In the Drawings

Remarks

Claims 1-3 are pending in the subject application. By this Amendment, claim 3 has been amended. New drawings are presented and the specification is amended above to reflect that. The undersigned avers that no new matter is introduced by this amendment. Upon entry of these amendments, claims 1-3 will be before the Examiner. Favorable consideration of the pending claims is respectfully requested.

FIGURE 4

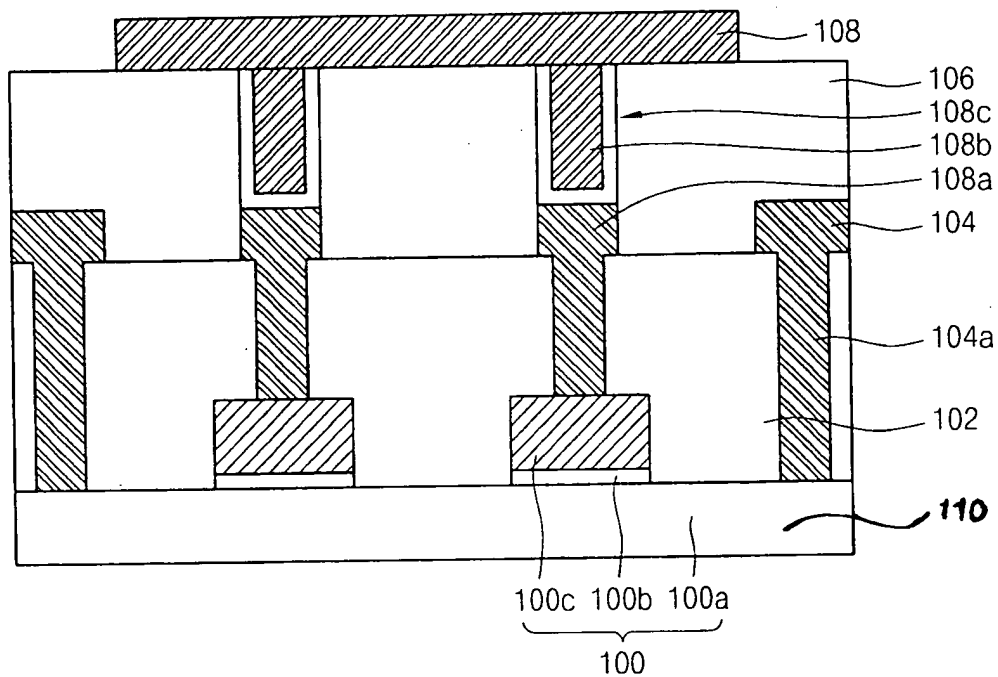
Please replace Figures 4 and 5A-5D with the corrected drawings sheets attached hereto.

The drawings are objected to at pages 2-3 of the latest Office Action. Submitted herewith are corrected drawing sheets in compliance with 37 CFR 1.121(d). Figures 4, 5A-5D have been amended to show a “semiconductor substrate”. The specification has been correspondingly amended to include a reference number for the “semiconductor substrate”. Applicant asserts no new matter has been added by these amendments.
